9488 | SIM, Combined Projects
29/01/2026

Lower Byrom Street Gateway / HVM, Science and Industry Museum, Liverpool Road, Manchester, M3 4FP – Application for a Non-Material Amendment (NMA) attached to Planning Permission Ref: 143389/FO/2025

The plan extract below shows the gas main position (yellow line) and consented bollard positions.

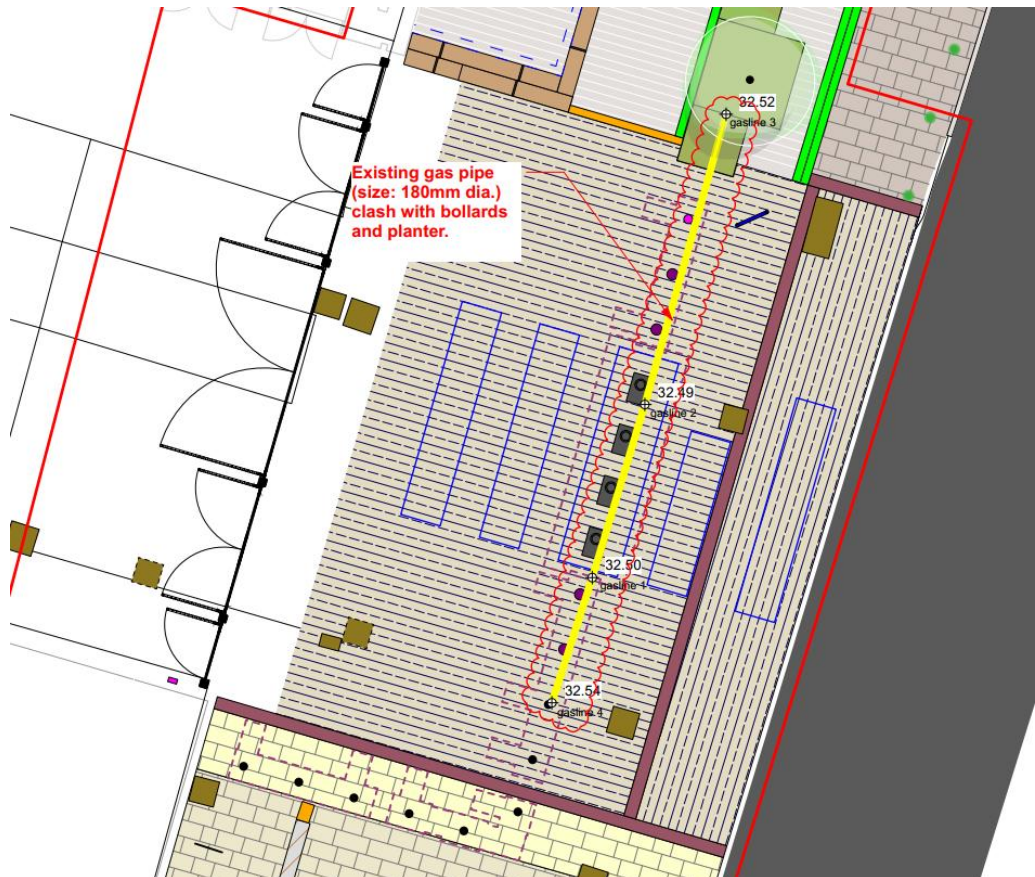
We seek permission to alter the position of automated & fixed bollards and planters, following the uncovering of a buried gas main.

During the course of the onsite works, the contractor discovered an existing gas main running through the location of the originally proposed PAS-rated automatic bollards.

This was not indicated on the utilities survey drawings and therefore the issue was unforeseen. To resolve the clash, the main arrangement of proposed bollard in front of the entrance gates have been revised and moved by approximately 1200mm. One no. of bollards was removed. Confirmation of the gas main easement has been obtained from Cadent, which confirms that a minimum clearance of 300 mm is required to the foundation of the bollards. The revised arrangement maintains a minimum separation of 300 mm between the bollard foundations and the gas main, ensuring compliance with these easement requirements.

This move had a minimal knock-on effect on the planter positions and the bollard row between the planters, which were also moved west by approximately 300mm. The planters were spaced a bit further apart to achieve a spacing that meets PAS rating compliance. As a consequence of the revised layout, the extent of the secure area has been reduced; however, this reduction is not considered significant.
